M3 Junction 9 Improvement

8.9 Applicant Comments on Local Impact Reports

Regulation Number:	5(2)(q)
Planning Inspectorate Scheme Reference:	TR010055
Application Document Reference:	8.9
BIM Document Reference:	HE551511-VFK-HGN-XXXX_XX-RP-IM-40005
Author:	M3 Junction 9 Improvement Project Team, National Highways

Version	Date	Status of Version
Rev 0	17 July 2023	Deadline 3

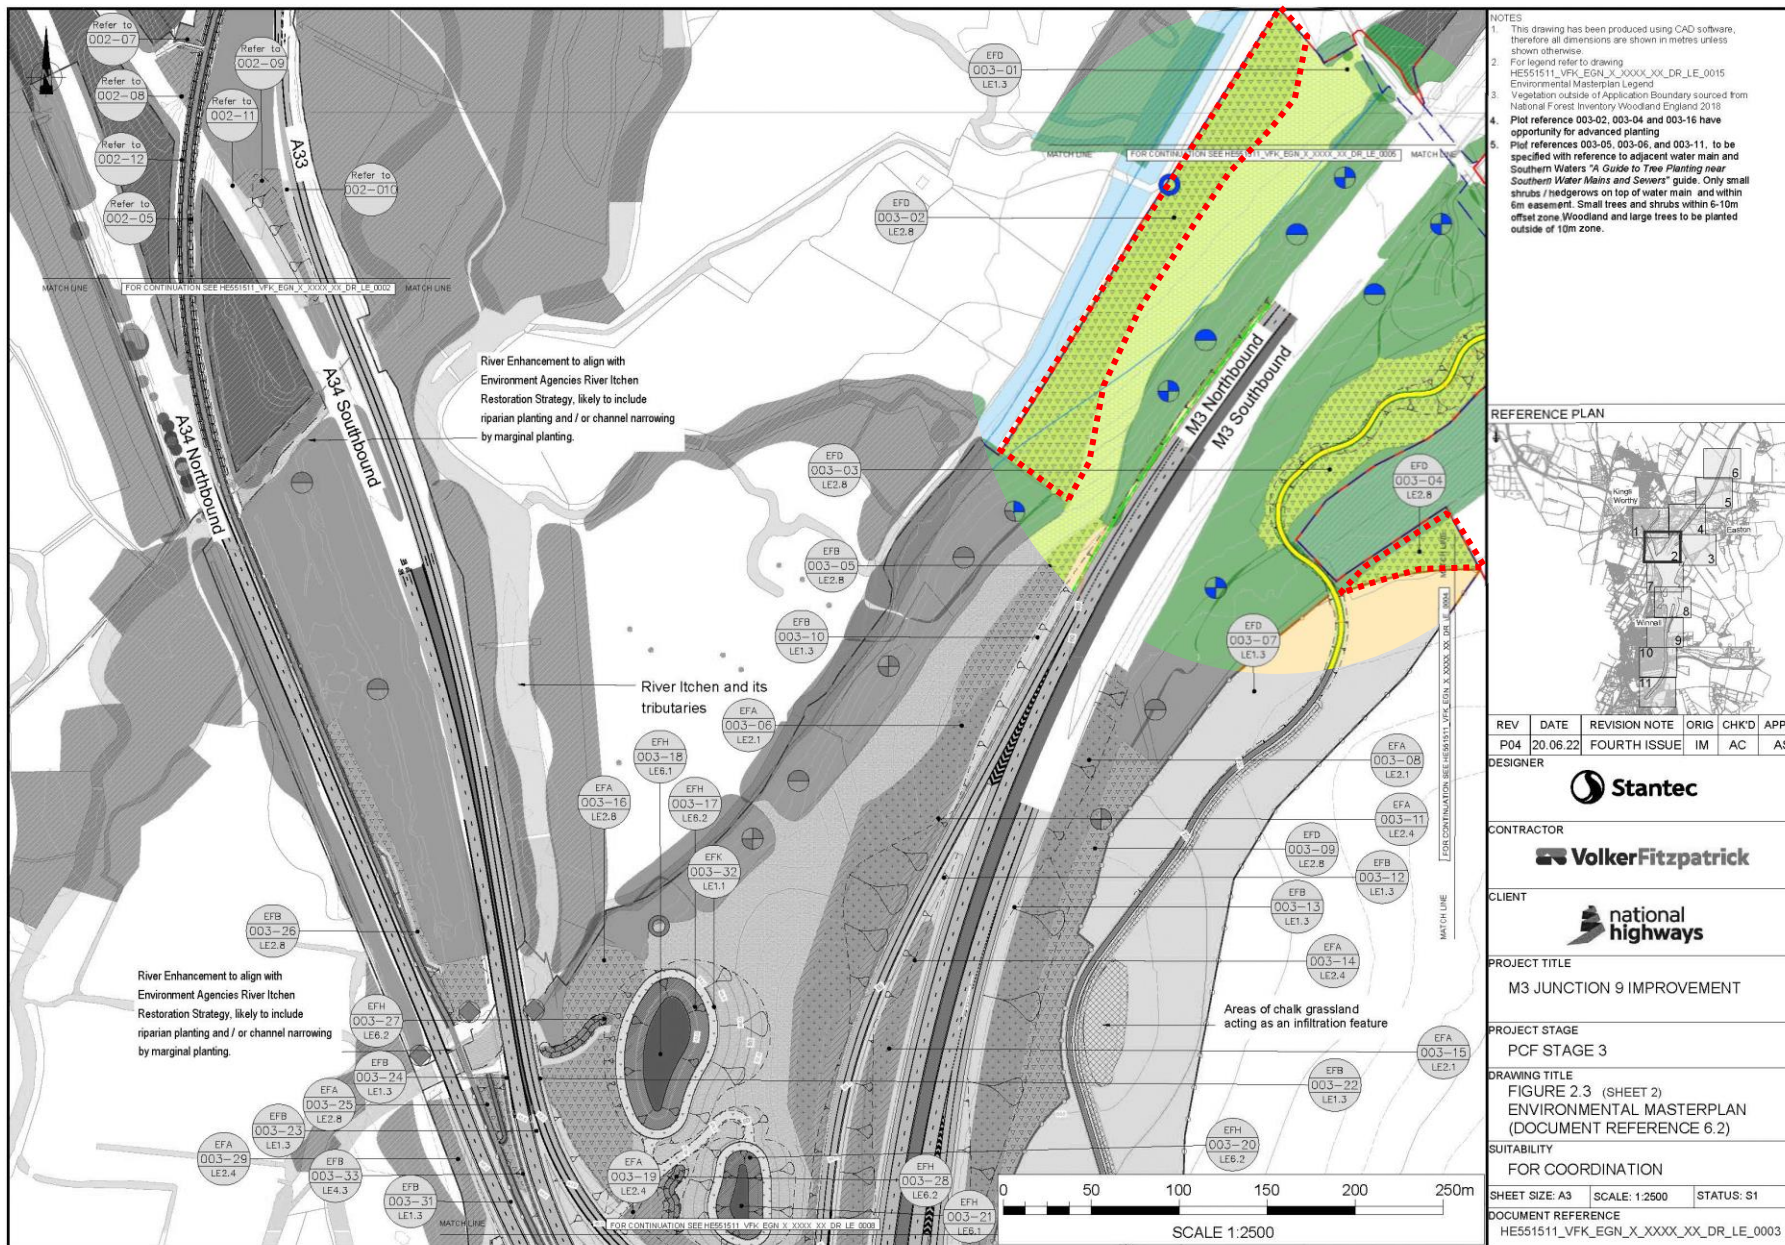
Comments made related to 'Issue 2: Vegetation Clearance', as shown below:

- Approximately nine hectares of vegetation is proposed to be removed. Loss of trees along the eastern side of the M3 will open up views of the motorway corridor, the new infrastructure and increased activity within it. It will also open up views from within SDNP across the valley towards built up parts of Winchester.
- Recommendation: Advanced planting is undertaken to minimise the opening up of views as much as possible.
- **A Further Information Request was made for a plan showing the locations of advanced planting accompanied by a rationale for them.**

The M3 Junction 9 Improvement Scheme includes a commitment to undertake advanced planting for landscape and visual mitigation purposes in a range of locations. The areas are identified on the **Figure 2.3 in Chapter 2 (The Scheme and its Surroundings – Figures (Part 2 of 4))** of the **Environmental Statement (ES) (6.2, REP2-029)** and referenced in **Appendix 7.6 (Outline Landscape and Ecology Management Plan)** of the **ES (6.3, APP-102)**. A commitment to advanced planting is set out in the **Record of Environmental Action and Commitments (REAC) Ref LV16** within the **first iteration Environmental Management Plan (7.3, Rev 3)**.
